In re: Deep bore tunnel project in Seattle

First, it is a comment on the Final EIS for the SR 99 Tunnel that I request be entered into the SR 99 Tunnel Record of Decision with a response from authorities. This letter is cc Transportation Secretary Hammond and her FEIS team, so that will happen without further action on your part.

Map of SR 99 surface transit option from Appendix W of FEIS

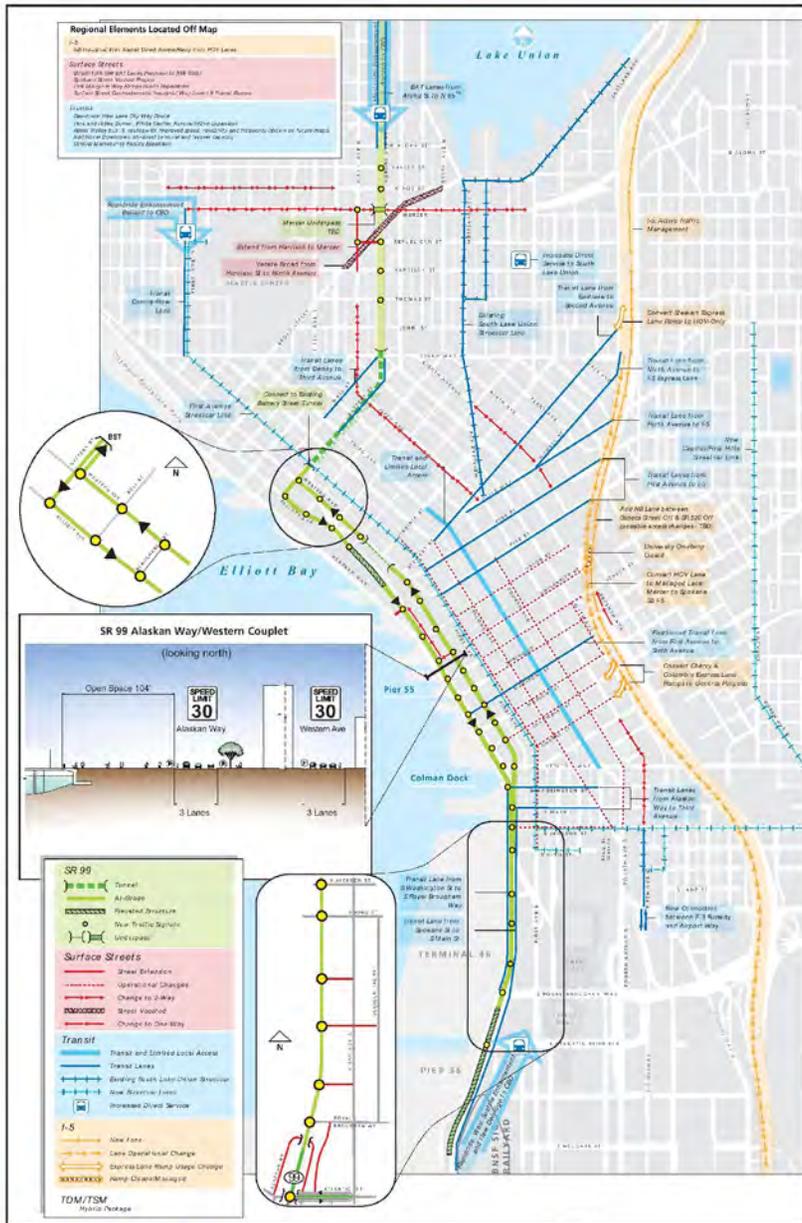
The SR 99 surface-transit alternative developed in the Partnership Process of 2007 and described in Appendix W in the SR 99 Tunnel FEIS, shown on the map on page 459, and inserted at the end of this letter, is likely not the best possible design to maximize north-south capacity and minimize travel time through downtown Seattle. These two measurements are why this alternative was screened out from further consideration in the Final EIS. The design reflects that it was, after all, a horse built by a committee.

I base my negative judgment of the surface alternative dismissed in the FEIS on my inspection of the map attached to the bottom of this letter which shows, for example, a waterfront sidewalk width of 104 feet and a speed limit of 30 mph, just to name two

characteristics that I believe could be modified to create a higher-throughput design. There are others.

The lead agencies appreciate your perspective on the design of the I-5, Surface, and Transit Hybrid scenario. Modest design modifications (sidewalk width and speed limit), as suggested, would not adequately address the capacity deficiencies of this scenario. The transportation analysis for the I-5, Surface, and Transit Hybrid is discussed in the Final EIS Chapter 2, Question 7, and Final EIS Appendix W, *2011 Surface and Transit Scenario Year Analysis Results*.
